UPWARD EXTENSION OF BENNETT'S COURTYARD Planning application reference 20/P3364 A response by Wandle Valley Forum February 2021

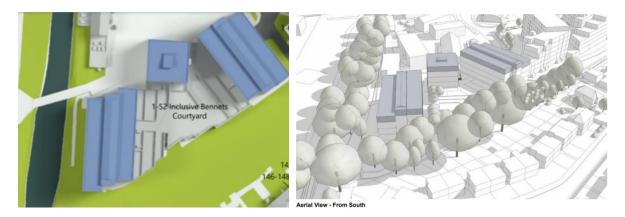
4. We do not consider that the upward extension helps the integrity of the existing architecture but the impact is relatively marginal in relation to the elevations facing Merton Abbey Mills and Prospect House.

5. We have significant concerns about the impact of the upward extension on the elevation facing the Wandle. This has a negative impact on the Conservation Area where development is legally bound to preserve or enhance its character.
